Field Fix for sagging **Inline Riser Assemblies** that were introduced on March 1, 2022 on Info Update 2057.

ACE VERSION
PN XP-00547
ASSEMBLY: ACE CLIP-ON BRACKET W/SCREWS

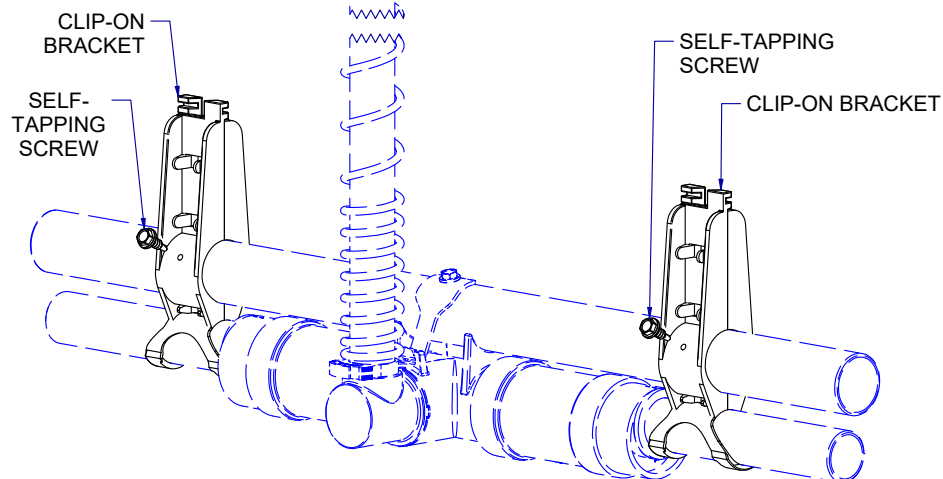
Based on the type of drinker line pipe (Ace or Big Ace/Big Z/1" PVC) install the Field Fix Assemblies as noted in the chart and illustration below.

Inline Riser Assembly:	Field Fix:
PN 3977 (Ace Version)	PN XP-00547 ASSEMBLY: ACE CLIP-ON BRACKET W/SCREWS
PN 3971 (Big Ace/Big Z/1" PVC Version)	PN XP-00532 ASSEMBLY: MODIFIED CLIP-ON BRACKET W/SCREWS
